Work Order ID 98328

Item ID: D3394-043 Accept ***N900040100*** Setup Start ***NS1***
 Revision ID: Stop ***NS2***
 Item Name: Lug Assembly
 Start Date: 3/11/13 Start Qty: 24.00 ***24*** Cust Item ID:
 Required Date: 3/22/13 Req'd Qty: 24.00 ***24*** Customer:
 Reference:

DRAWING NO. D3394	TITLE LUG	REV. B	DART AEROSPACE LTD ENGINEERING ORDER		D.E.O. NO. D3394-B-1	SHEET NO. SHEET 1 OF 1	SCALE NTS
DRAWN AJS	CHECKED	MFG. APPR.	APPROVED		DE APPR.		
DATE 09.11.04	DATE 09.11.04	DATE 09.11.04	DATE 09.11.04		DATE 09.11.04

DRAWING NO. D3394	TITLE LUG	REV. B	DART AEROSPACE USA, INC ENGINEERING ORDER		D.E.O. NO. D3394-B-2	SHEET NO. SHEET 1 OF 1	SCALE NTS
DRAWN <i>qp</i>	CHECKED <i>Sc</i>	MFG. APPR. <i>M</i>	APPROVED <i>MP</i>		DE APPR. <i>MP</i>		
DATE 11.05.02	DATE 11.05.09	DATE 11.05.09	DATE 11.05.09		DATE 11.05.09

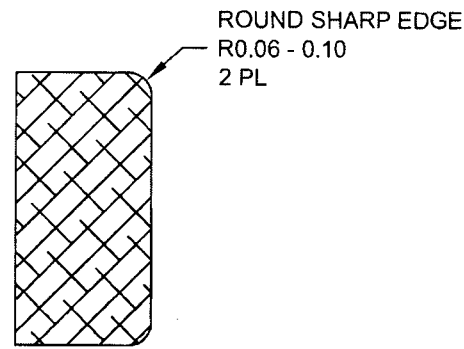
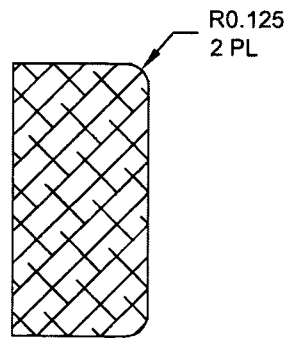
SHEET 4 ZONE A,1 MODIFY SECTION A-A AS SHOWN:

REASON: DRAFTING ERROR

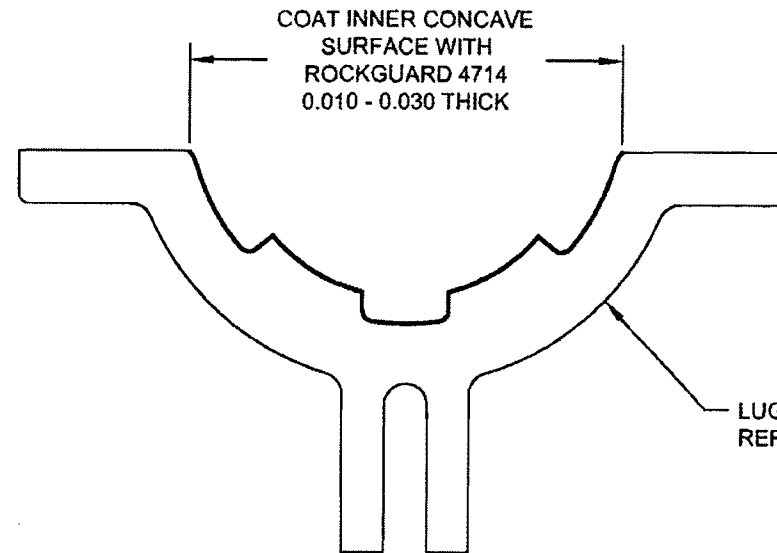
ADD D3394-xRG OPTION

D3394-xRG MOUNTING LUGS ARE INDENTICAL TO D3394-x MOUNTING LUGS, HOWEVER AFTER FINISH, COAT INNER CONCAVE SURFACE WITH "PLUS ONE ROCKGUARD 4714" AS SHOWN BELOW.

D3394-1RG LUG (SHOWN)
D3394-3RG/-5RG LUGS (SIMILAR)
D3394-041RG/-043RG/-045RG LUG ASSEMBLIES (SIMILAR)
